Access Compliance Report

Public Rights-of-Way

(Curb Ramps)

Intersection ID: 43846	Main Street: CURRIER_RD	Cross Street: BRADSTREET_COMMONS_WY	Location: NE
ADA ID: 61E49B85C803	Ramp Type: PerpDiag	Initial Pass/Fail: Fail	Overall Compliance: No
		Severity Score: 22.5

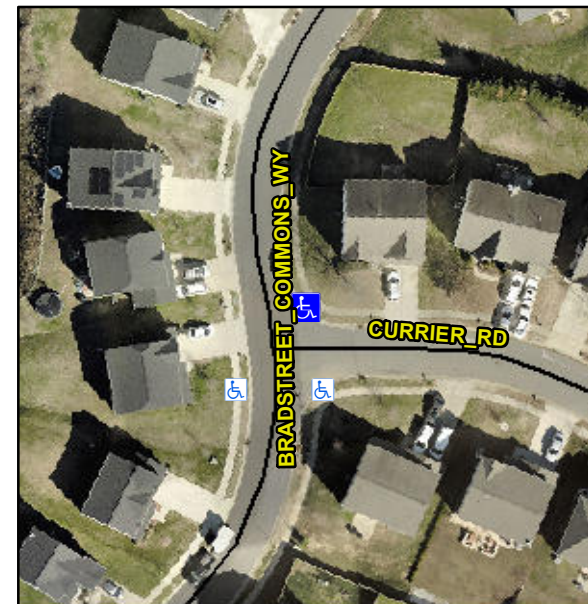
Not Found, R304.5.1, R304.2.2, R304.5.3

Compliance	Description	Data	Compliance	Description	Data
N/A	Ramp Length (in)	48.0	No	Ramp Slope (%)	9.8
No	Ramp Width (in)	47.0	No	Ramp XSlope (%)	3.4
N/A	Flare Type LT	N/A	N/A	Flare Type RT	N/A
N/A	Flare Slope LT (%)	N/A	N/A	Flare Slope RT (%)	N/A
N/A	Flare Traversable LT?	N/A	N/A	Flare Traversable RT?	N/A
N/A	Landing Length (in)	N/A	N/A	DWS Provided?	N/A
N/A	Landing Width (in)	N/A	N/A	DWS Contrast?	N/A
N/A	Landing Slope (%)	N/A	N/A	DWS Length (in)	N/A
N/A	Landing X Slope (%)	N/A	N/A	DWS Full Width?	N/A
N/A	Landing Curb? (Y/N)	N/A	N/A	DWS Offset (in)	N/A
N/A	Shared Landing?	N/A			
N/A	Gutter Ponding?	N/A	N/A	Gutter Slope (%)	N/A
N/A	Gutter Lip Ht (in)	N/A	N/A	Gutter X Slope (%)	N/A
N/A	Painted X Walk1?	No	N/A	Painted X Walk2?	No
	X Walk 1 Direction	To W		X Walk 2 Direction	To S
N/A	X Walk 1 Width (in)	N/A	N/A	X Walk 2 Width (in)	N/A
	X Walk 1 Slope (%)	0.2		X Walk 2 Slope (%)	3.6
	X Walk 1 X Slope (%)	3.6		X Walk 2 X Slope (%)	1.7

Remove & Replace Curb Ramp With Two New Directional Ramps or Equivalent.
